ORIGINATION FORM

Proposed Revisions to a Standard Plans Index
(Please provide all information — Incomplete forms will be returned)

Index Number: 450-199
Sheet Number (s): Sheet 1
Index Title: PRESTRESSED I-BEAMS BUILD-UP & DEF
DATA

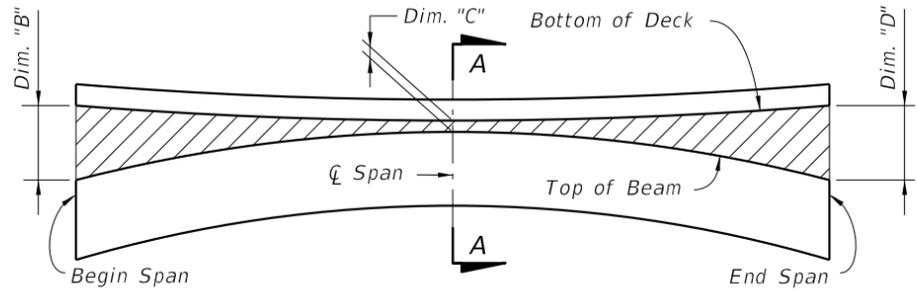
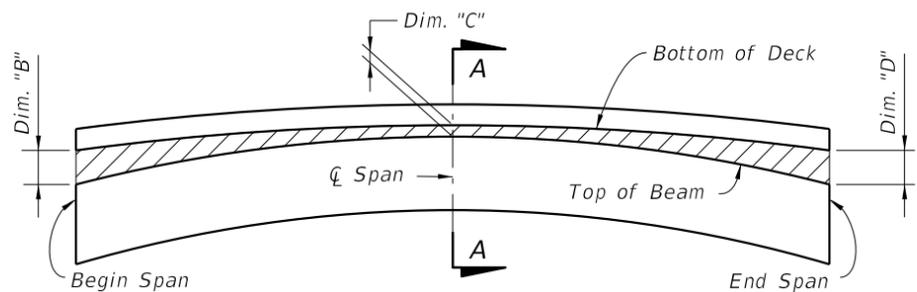
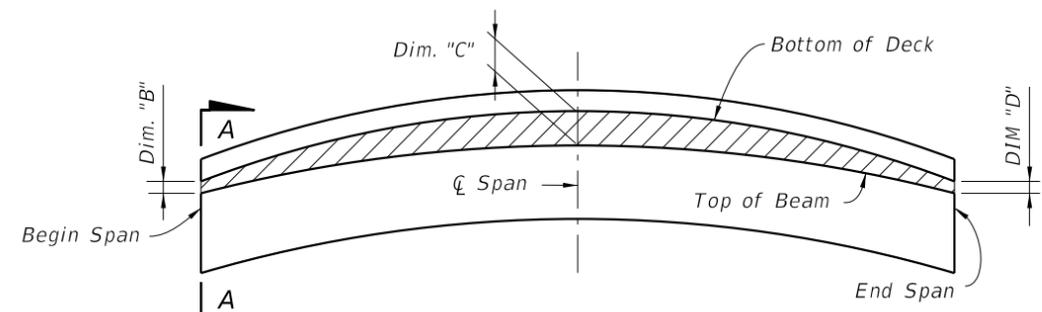
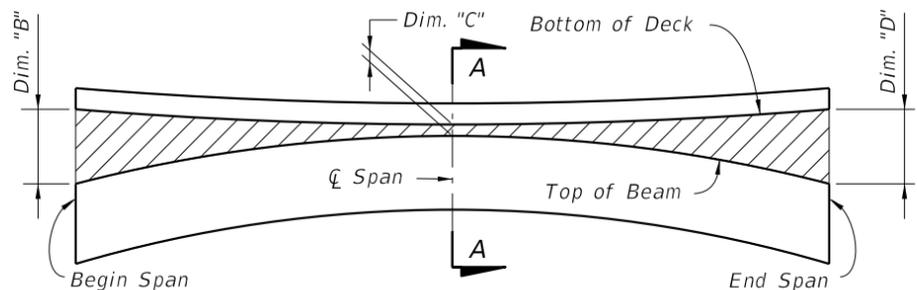
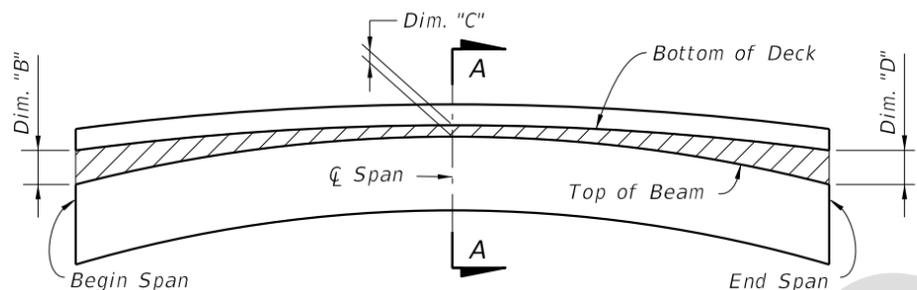
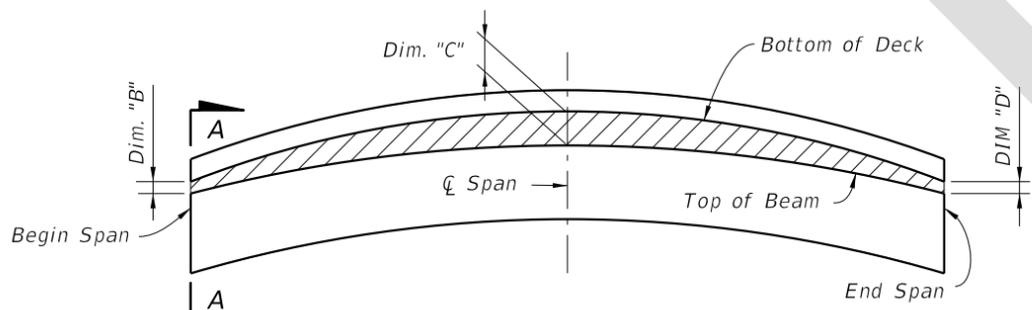
Change the camber tolerance 1" from 1/2".

The build-up values given in the Data Table* are based on theoretical beam cambers. The Contractor shall monitor beam cambers for the purpose of predicting camber values at the time of the deck pour. If the predicted cambers based on field measurements differ more than $\pm 1/2$ " from the theoretical "Net Beam Camber @ 120 Days" shown in the Data Table*, obtain approval from the Engineer to modify the build-up dimensions as required. When the measured beam cambers create a conflict with the bottom mat of deck steel, notify the Engineer a minimum of 21 days prior to casting.

The build-up values given in the Data Table* are based on theoretical beam cambers. The Contractor shall monitor beam cambers for the purpose of predicting camber values at the time of the deck pour. If the predicted cambers based on field measurements differ more than +/- 1" from the theoretical "Net Beam Camber @ 120 Days" shown in the Data Table*, obtain approval from the Engineer to modify the build-up dimensions as required. When the measured beam cambers create a conflict with the bottom mat of deck steel, notify the Engineer a minimum of 21 days prior to casting.
